Reg. Welspun Energy Thermal Power PLant in Dadri Khurd, Mirzapur- Comments on Response Received from M/s Welspun Energy U.P. Pvt. Ltd. on our Representation to EAC dated 15th November, 2013

Reply Submitted by Welspun U.P. Energy Pvt. Ltd (Recvd. on 15th February, 2014)

Vindhya Bachao's Site Visit Report submitted to Expert Appraisal Committee-Thermal Power Projects and Coal Mines, MoEF (on 15th November, 2013)

Fig. 1: LANDSAT data analysis acquired from University of Maryland-Global Forest Cover Mapping Tool

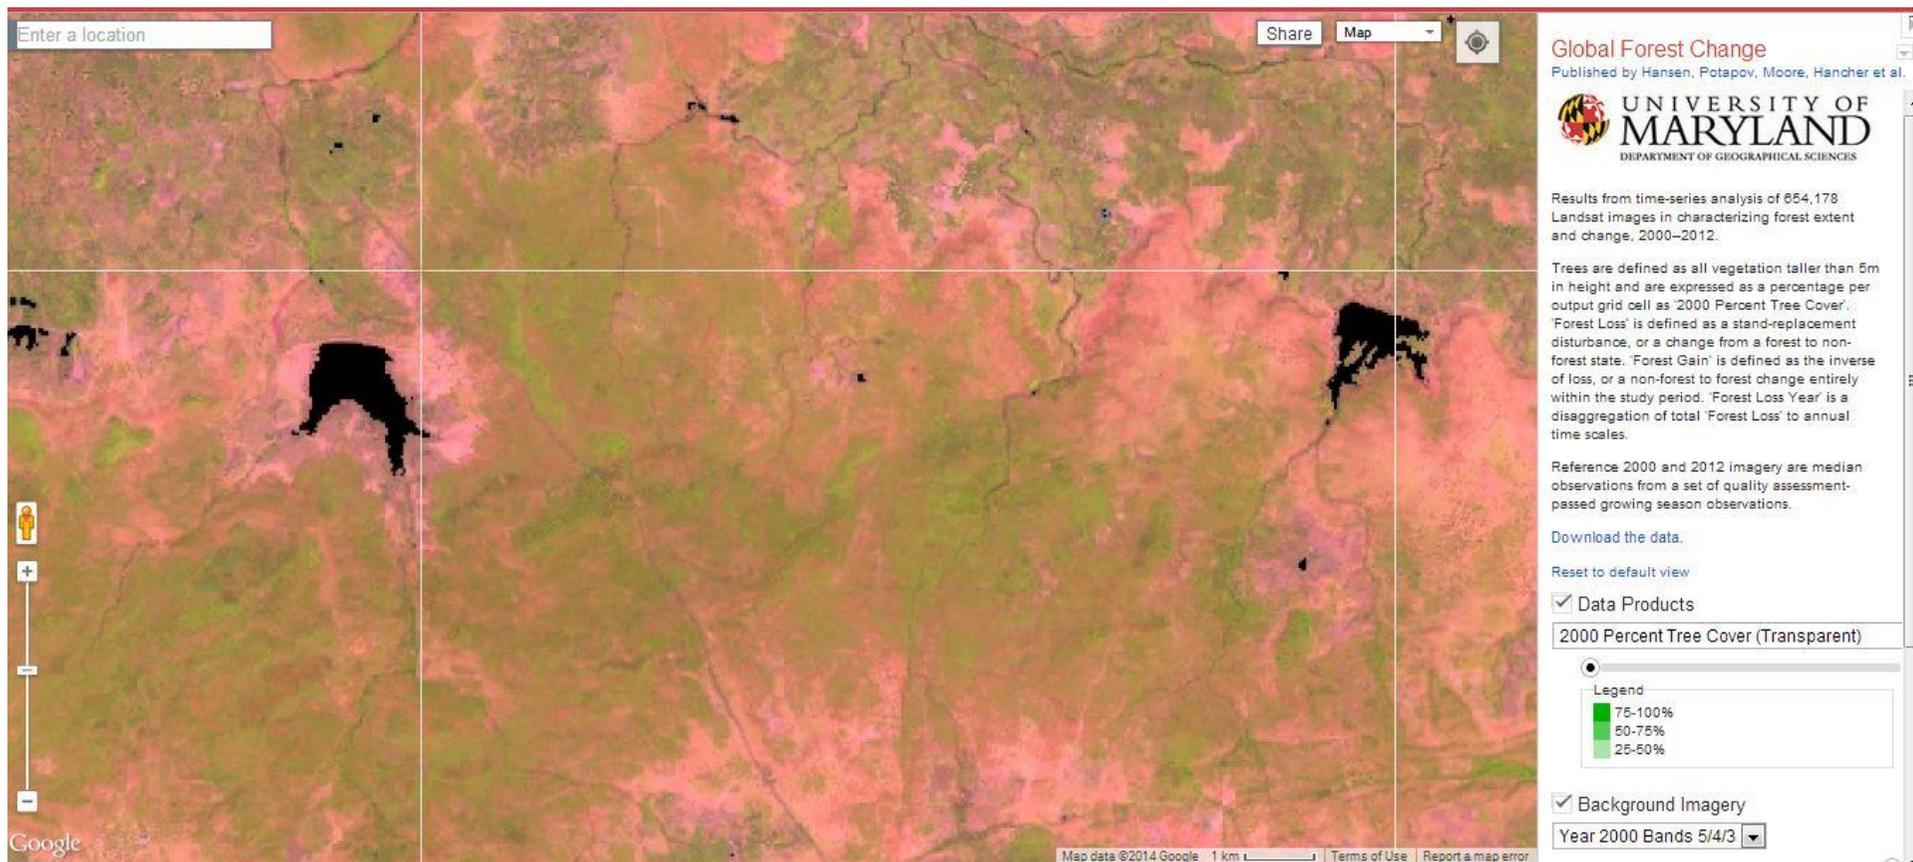
v)	The project is not barren as claimed in the EIA report. There happens to be similar forest as found in the reserve forest area with good vegetation cover. It can be referred as mix forest with mixture of trees, shrubs and grasses.	The proposed project land area is 875 acres out of which 97.58 % is barren land, 1.78% is single crop agriculture land, 0.62 % is human settlement & 0.02 % is water body as per revenue records received from the District Administration. The project is proposed to be located in revenue land. In case of the forest land, diversion will be done as per the provision of Forest Conservation Act, 1980	As in next para it has been admitted by the project proponent itself that there are 6 Schedule I species, hence no clarification is required if this land is barren. Following points counters the claim of barren land of the project site. Presence of so much diversity of endangered animals and vast floral diversity shows there is good biodiversity inside the project site. A LANDSAT data analysis of forest cover around the world by University of Maryland accessed as on 6 th March, 2014 clearly shows forest with very good forest density of around 75% in the project site and the regions surrounding it. The percent of forest cover should be done based on scientific analysis for the purpose of EIA. We want to outline the following points regarding the satellite image provided by the project proponent:

<ol style="list-style-type: none"> 1. The date of acquisition of the satellite data is not provided in the EIA report. 2. The initial survey and environmental baseline monitoring was carried out during the period of March, 2011 to May, 2011. This is a season of leafless for any deciduous tree species and increased chances of incidents of forest fires. Thus the landscape would more or less be dry and barren. Hence, this is not suitable period for analyzing any forestry related issues. 3. The proponent has not shown any false colour composite of the study area. 4. No vegetation type map at least showing the major forest types of the region is provided in the EIA report. 5. They have not mentioned the accuracy of the classification. 6. Besides, their survey has mentioned that <i>Butea monosperma</i> and <i>Zizyphus</i> species are dominant in scrub, <i>Butea</i> occurs in groups between there is lot of empty space, thus it gives a mixed spectral response with the soil, thus giving the appearance of a barren land. 7. In the land use map they have provided in the EIA report, it itself shows forest boundary crosses the plant site. It also shows scrub, fallow and human settlements. Surrounded on all sides are dense forests, degraded forest and scrub. 8. As per para 3.10.203 and para 4.3.1 in the EIA report, the project site is repeatedly claimed to be barren, scrub and fallow agricultural land. However in the satellite image they have provided, there is no fallow land in near proximity and is at far off distance. 9. They have not defined in the EIA report, which definition they have followed for declaring any region as 'forest land', 'forest', 'barren land', 'fallow land', 'degraded forest'. They should have given the reference for all those in the EIA report.
